HOWARD COUNTY HISTORIC PRESERVATION COMMISSION

May Minutes

Thursday, May 5, 2016; 7:00 p.m.

Figure 6 - Site

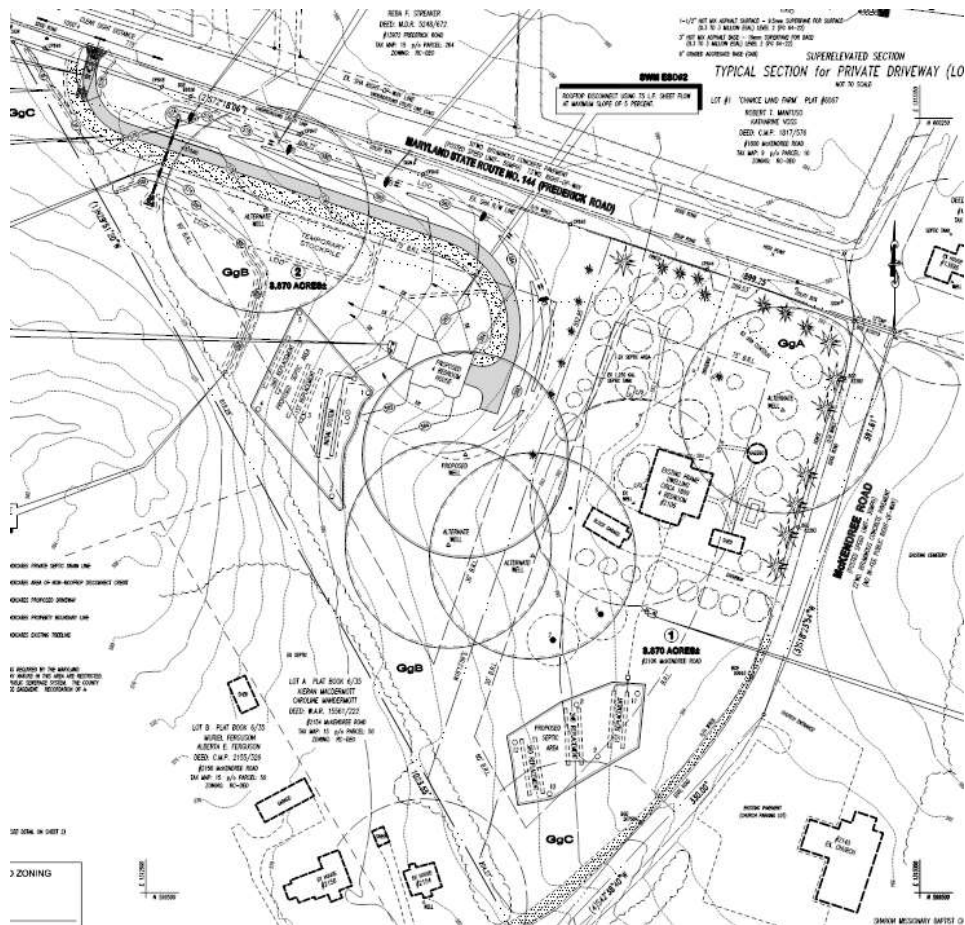
Staff Comments: Staff supports the design of the plans as submitted. The historic house will be situated on its own lot, which will retain the historic setting to include vegetation and the driveway entrance brick walls and piers. The proposed plan complies with Section 16.118 of the Subdivision and Land Development Regulation for the protection of historic resources, “historic buildings, structures and landscape features which are integral to the historic setting should be located on a single lot of suitable size to ensure protection of the historic structure and setting” and “access to the historic property should be via its existing driveway, wherever possible.” The proposed lot size will encompass all environmental features that are associated with the house and the original circular driveway will remain functional.

Section 16.118 states, “the new subdivision road should be sited so that the lot layout does not intrude on the historic resources. The road should be oriented so that views of the historic property from the public road are of its primary façade.” As proposed, the driveway for the vacant lot will not intrude on the historic house. However, if the plan had to be altered for a use-in-common driveway, the historic setting would be irreversibly destroyed as it is likely the brick entrance walls and piers, as well as mature landscaping, would need to be removed.

Staff Recommendation: Staff recommends the Commission endorse the plan as submitted, which preserves the historic house in its historic and environmental setting.

Figure 10 - Proposed addition

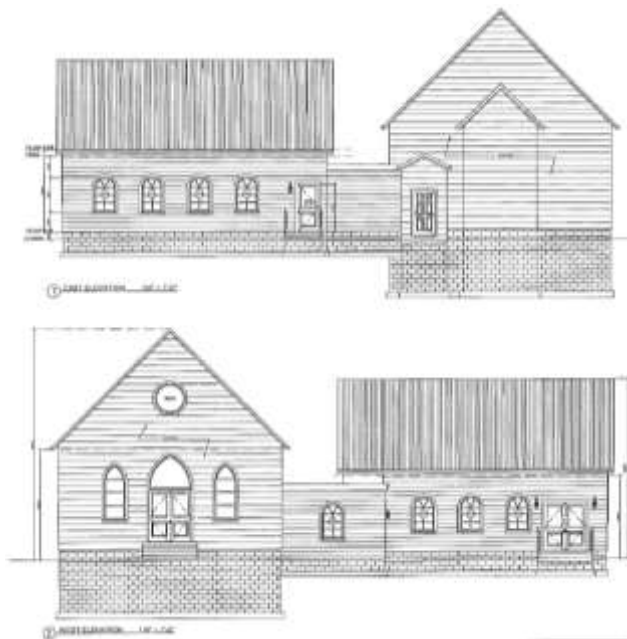
Staff Comments: The addition complies with the Secretary of the Interior Standards for Rehabilitation, “new additions, exterior alterations, or related new construction shall not destroy historic materials, features and spatial relationship that characterize the property. The new work shall be differentiated from the old and shall be compatible with the historic materials, features, size, scale and proportion, and massing to protect the integrity of the property and its environment” and “new additions and adjacent or related new construction shall be undertaken in such a manner that, if removed in the future, the essential form and integrity of the historic property and its environment would be unimpaired.” The addition will be on the side of the church and will only minimally affect the historic structure. The historic structure has been covered in asbestos siding for many years, but most likely has German lap siding underneath. The proposed HardiePlank lap siding for the new addition is compatible, but distinctive, from the asbestos and underlying wood lap siding. The arched windows are also compatible with the pointed arch Gothic windows on the historic church, without being an exact replication. The overall proposed design and scale of the addition is secondary in size and placement to the historic church. Staff finds the addition is complementary to the historic church building.

Section 16.118 of the County Code states, “Cemeteries should be dealt with in accordance with subtitle 13 of this title. In any case, no grading or construction shall be permitted within 30 feet of a cemetery boundary or within ten feet of individual grave sites.” Staff does not know where the information from the Cemetery Inventory originated from or when it dates to. However, if any graves are found during construction, the Applicant needs to stop building and contact the Department of Planning and Zoning (DPZ).

Ms. Zoren stated that she finds the new rounded arched windows are competing with the pointed arched windows on the church. Mr. Dorsey said the original windows could never be duplicated exactly. Ms. Tennor recommended using plain, square windows so they wouldn't compete. Mr. Dorsey stated the proposed arched window would be consistent with the church, but that they are open to the Commission's recommendation of square windows.

Staff Recommendation: Staff has no objection to the proposal, but advises the Applicant to confirm in advance of construction that there are no gravesites within the construction area.

Figure 14 - Proposed alterations to front

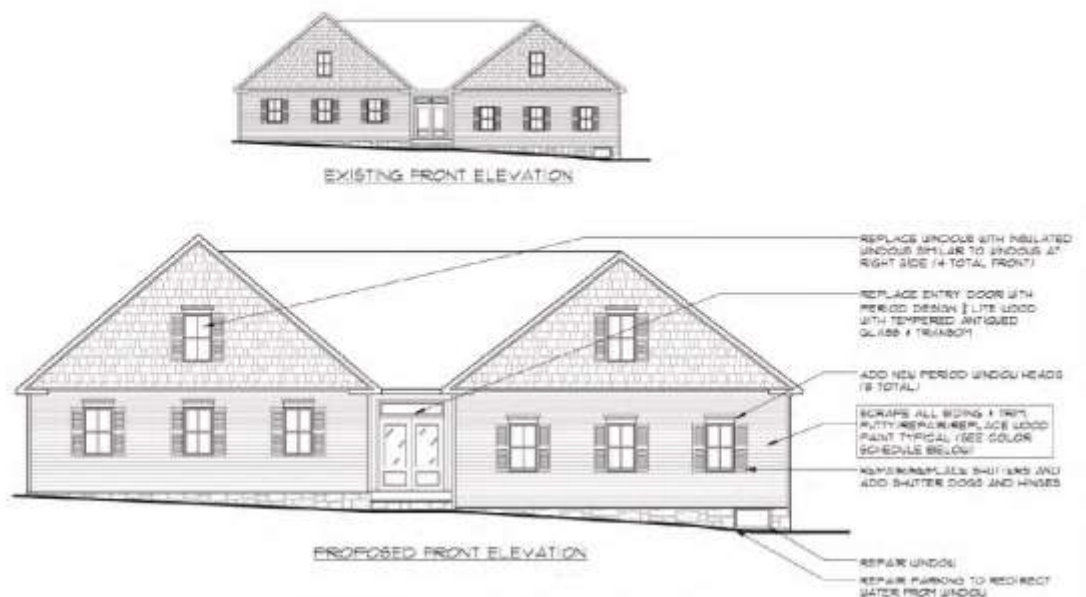
Staff recommends against the replacement of the wood windows with the aluminum clad windows on the 1984 building. Chapter 6.H recommends, “maintain and repair original window openings, frames, sashes, sills, lintels and trim” and recommends against replacing “sound wood windows and frames, even if paint, putty and glazing need repair or replacement.” Additionally the Façade Improvement Program Design Guidelines state, “replace modern features...with historic, traditional building materials” and recommends against, “removing and replacing historic building materials with modern building materials.” While the windows on the historic building may be aluminum clad wood, Staff cannot find any record that this was an approved change. When the new building was constructed, it seems a lot of care went into using historic building materials, such as wood siding and windows. Staff finds the replacement windows on the historic building stand out as modern replacements with an obvious simulated divided lite and should not be replicated on the building.

When the addition was originally constructed, the windows were shown with pediments/window heads, but those were specifically not approved at that time. Likewise, Staff finds the addition of that decorative element is not historically appropriate as it was not found on this building prior to the addition, nor is it found on the neighboring buildings. Staff recommends denial of the pediment/window heads.

The Applicant proposes to install a $\frac{3}{4}$ lite over 1 panel wood door with a 1 lite transom above. The inventory form for this building, which dates prior to the addition, states, “Its central rectangular cross paneled doorway is surmounted by a two lite transom and flanked by rectangular double hung windows with two over two lites.” Staff recommends the Applicant install a two lite or four lite transom, which would be more historically in-keeping

with the structure prior to the alterations. The original drawings for the addition show a 4 lite transom over double 4 panel doors. It is unknown if the building was constructed differently from the approved plans or if it was altered later on. There are several photos of this building before the addition was constructed that show the original 5 panel door. Chapter 6.G recommends, "Replace inappropriate modern doors with doors of an appropriate style. If documentary evidence of the original door is available, choose a new door similar to the original. Otherwise, use a door appropriate to the period and style of the building." Staff has no objection to the proposed ¾ over 1 panel door, which is not replacing the original door (as the original door was converted to a window when the addition was built). However, Staff finds it would also be appropriate to either use a 5 panel door, or a ¾ lite over 2 panels in respect to the original door on this building.

- 1) Approval of 'Entire Building' Items 1 & 2 and tax credit pre-approval.
- 2) Approval of '1984 Side of Building' Item 1.
- 3) Approval of 'Front Elevation' Items 1-4 and tax credit pre-approval. Item 2 should be replaced with a wood window.
- 4) Approval of 'Front Elevation' Item 5 if wood, not composite is used and tax credit pre-approval.
- 5) Denial of 'Front Elevation' Items 6 & 7.
- 6) Approval of 'Rear Elevation' Items 1 & 2.
- 7) Denial of 'Rear Elevation' Item 3.

Motion: Ms. Eileen Tennor moved to approve per Staff recommendations Numbers 1-7, with the exception of Number 6, Item 1. The Commission is denying the French balcony and the windows will remain. Ms. Zoren seconded. The motion was unanimously approved.

Figure 20 - Height of wall at street

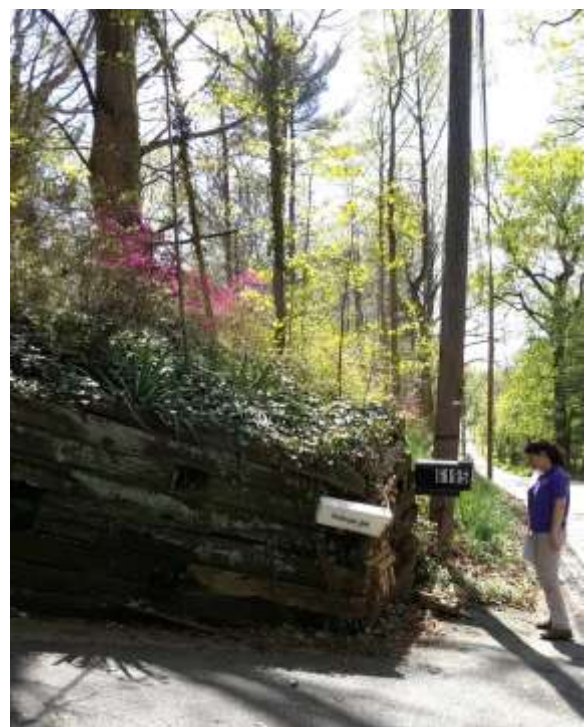
Staff Comments: Chapter 9.D explains, “because homes in Lawyers Hill fit into the natural contours of the surrounding hills, the need for retaining walls has been minimized, and they occur infrequently within the District. Retaining walls in the District are generally low, brick or stone walls that have been built to form decorative structures such as a flower bed or water fountain. High timber retaining walls have been used at one driveway entrance to minimize the need to clear and grade the adjacent slopes. New retaining walls that will be visible from public roads or neighboring properties should be unobtrusive and constructed or faced with brick or stone.” Staff is concerned about removing the timber walls and replacing it with the concrete segmented wall system. The Guidelines recommend, “design new retaining walls to be low and constructed or faced with brick or stone.” Staff does not find the proposed material is appropriate as is it not brick or stone, but a concrete product. The Guidelines recommend against, “retaining walls faced with timber, concrete or concrete block, unless these walls are not visible from a public road or neighboring property.”

The Guidelines also recommend, “where higher retaining walls are required, consider using a series of short, stepped walls with landscape plantings rather than one single high wall” and “soften the appearance of highly visible new walls by planting vines or other landscape materials that will cover the wall.” Staff has inquired with the Applicant if he has considered grading the site to achieve either a lower wall, or no wall, or if he has considered terracing the wall to reduce the overall height of the wall. The Guidelines also recommend, “minimize the need for new retaining walls by designing improvements, including driveways and parking area, to minimize clearing and grading.” Staff finds this recommendation is unclear and does not know the intent of the statement as it seems contradictory. In this instance, slight grading would reduce the need for a high wall.

Ms. Zoren stated that she was against the proposed material being used in the Historic District. She explained that it might look okay in the one block, but it looks industrial once the 6 foot high wall is constructed. She said it looks too modern and monotone. Ms. Zoren said that natural stone is more suitable, as there are variations in stone size and color. Mr. Errera said that natural stone is not strong

Staff Recommendation: Staff recommends the application be continued in order to determine the best solution for the replacement retaining walls.

Motion: Mr. Taylor confirmed that all parties agreed to continue the application June.

Figure 31 - Proposed internally lit sign

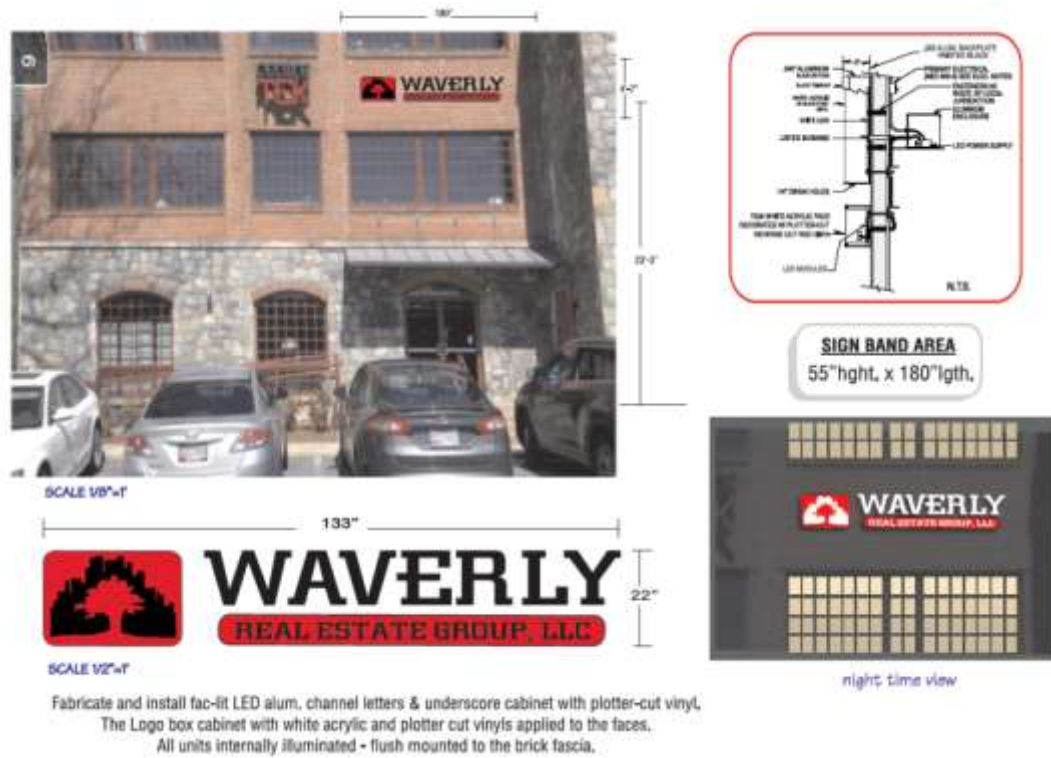
The Applicant and Commission agreed to continue the meeting after the Applicant mentioned another business would be installing a sign in the future. Staff finds the new proposals are not in keeping with the Guidelines. The 81 square foot sign is too large and not proportionate to the space. The internally lit signs do not comply with Chapter 11.A, which recommends, "use indirect lighting or concealed light fixtures with concealed wiring to illuminate signs. If the light source will be visible, select a fixture compatible with the style of the building. Minimize glare by focusing the light on the sign." The Guidelines recommend against using, "internally lit plastic signs" and "signs made of modern materials that do not relate to the historic structures."

Testimony: Mr. Shad stated that Mr. Reuwer was already sworn in. Mr. Shad asked if there were any additions or corrections to the Staff comments. Mr. Reuwer said he preferred the sign proposed on Figure 32. Ms. Holmes said that the sign does not comply with the Guidelines as it is internally illuminated, which the Guidelines specifically recommend against. Ms. Tennor said the building is not historic and she finds that something to consider. Ms. Holmes pointed out that the Commission has had other application on non-historic buildings on Main Street. Ms. Holmes said that signs with individual metal letters have been approved, such as on the Visitor's Center, so it doesn't necessarily have to be a panel sign. Ms. Tennor asked if the CenterTek sign was illuminated. Ms. Holmes said it is illuminated, but was researched with this application and found that it does not have any approvals or permits. Mr. Roth said the arrangement of the signs on the brick (Figure 32) is more appropriate than on the stone. Ms. Tennor agreed. Ms. Tennor said the signs look good, but do not look historic. Ms. Holmes said the goal is not to set a precedent for approving these signs throughout the Historic District and that similar constraints exist on historic Tonge Row. The Commission further discussed sign options. Mr. Reuwer asked if they could table the application again and he would get his sign company to mock up paneled signs on the brick building.

Staff Recommendation: Staff recommends approval of the sign presented at the April 2016 meeting to be 3 feet high by 5 wide as proposed by the Applicant in April. Staff recommends denial of all other signs proposed.

Motion: There was no motion, but the all parties agreed to continue the application to June.
